Upgrade Information of MPE720 Version 6.08

1.1 Version 6.08 Upgrade Information

Items added and features improved from MPE720 version 6.07 to version 6.08 are as follows.

No.3 Addition of "Absolute Encoder Reset Completed"

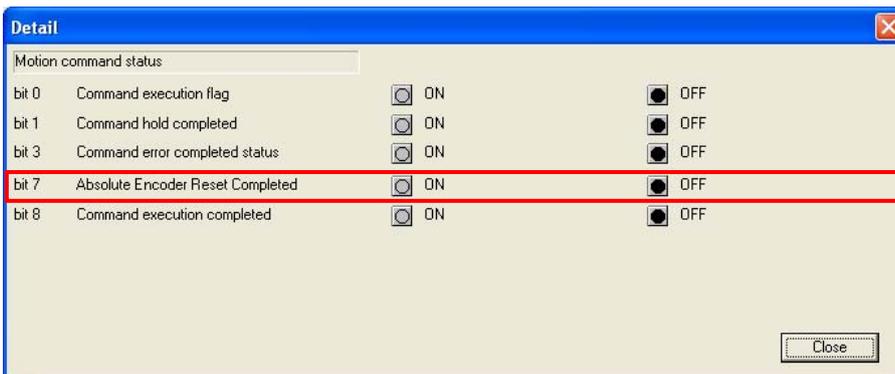
"Absolute Encoder Reset Completed" was added to the monitor parameter of the SVB module.

IWxxx09 Motion Command Status (bit 7)

No.5 SVA fixed parameter addition

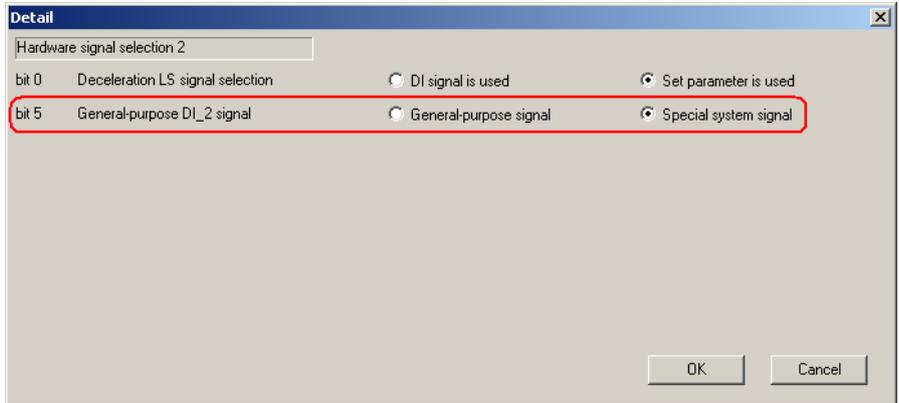
In SVA of the MP2000 series, the mode that interchangeable to CP9200 SVA operated about the operation of general-purpose DO_2 it was added.

Fixed parameter No.21 General-purpose DI_2 signal (bit 5)

No.6 Change in current value row attribute of I/O module

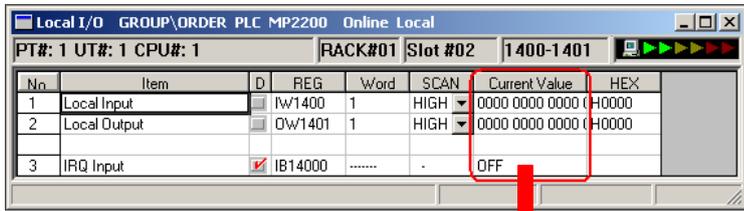
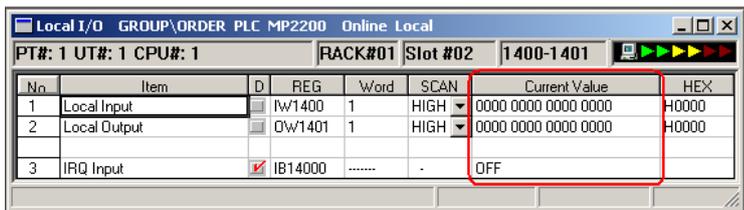
When the current value is get of I/O and BIN is displayed like the LIO module and the DO module, etc., the digit number of display might not be able to display 16 bit by the system requirements. It was corrected that the width of the row in the grid was able to be treated in changeability to display it even for this case.

When "Current Value" cannot display 16 bit.

It came to be able to display 16 bit by expanding the width of the row of "Current Value".

No.7 SVB monitor parameter addition

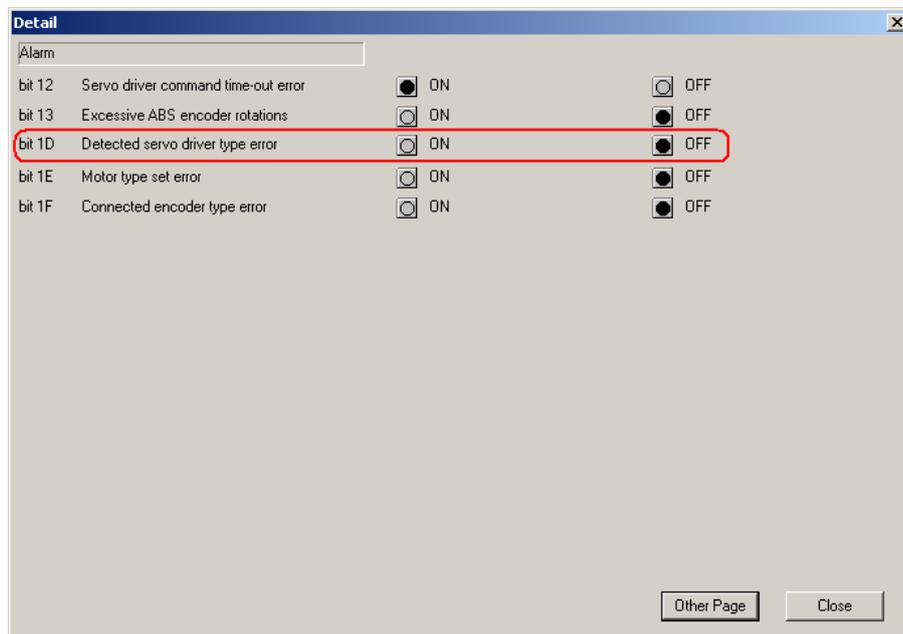
"Detected servo driver type error" was added to bit1D of motion monitor parameter 0x04 of SVB.

When the SERVOPACK allocated by the link assignment of the SERVOPACK and SVB actually connected with the motion module is different, bit1D is turned on.

No.12 In the watch subwindow, the operation of drag & drop of the register is changed from "Copy" to "Movement"

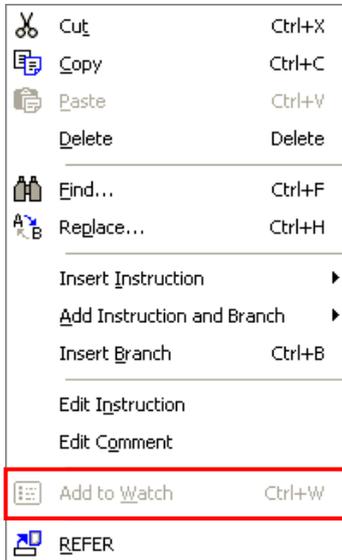
In the watch subwindow, "Copy" had been done up to now by the operation of drag & drop of the register. However, no "Copy" it, and "Movement" can be done by the operation of drag & drop.

No.14 In the watch subwindow, the input function of a consecutive address

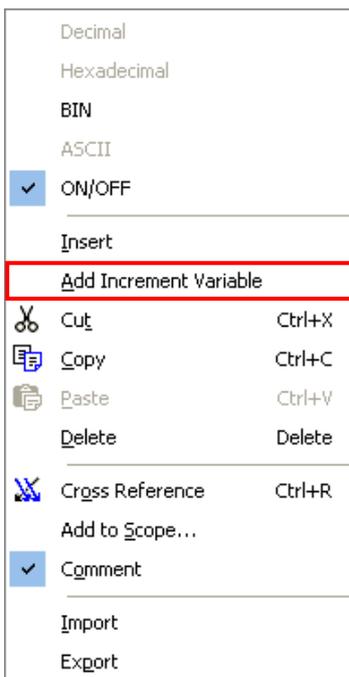
In the watch subwindow, "Add Increment Variable (A)" was added to the pop-up menu.

When "Add Increment Variable (A)" is selected, the value of the increment in the register address above from one position of the cursor can be registered by the automatic operation.

The address is done in the increment according to the size of the data type of BIT, WORD, LONG, FLOAT, ADDRESS. Moreover, when the address exceeds the size, it is not possible to register.

No.16 Pop-up menu Addition of watch subwindow

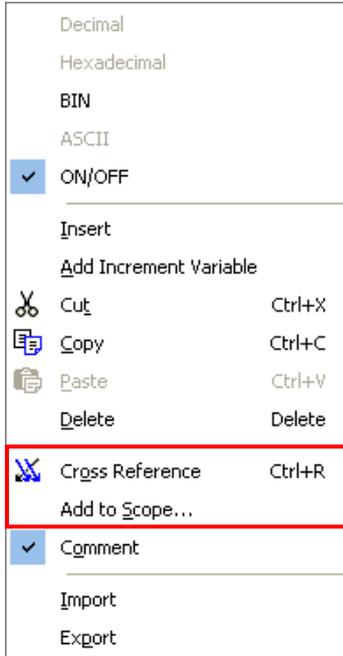
In the watch subwindow, "Cross Reference (Q)" and "Add to Scope... (S)" were added to the pop-up menu.

No.21 It is trouble that display of color of register list shifts

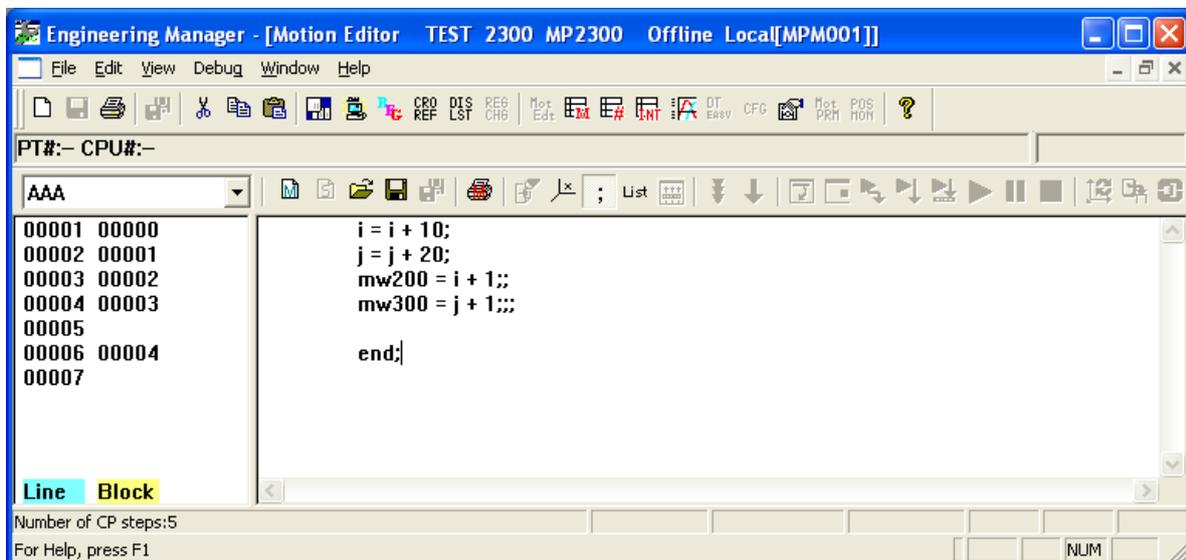
In the register list, the display of the background color shifted when the list was scrolled.

In the register list, it was corrected that the background color did not shift even if it scrolled.
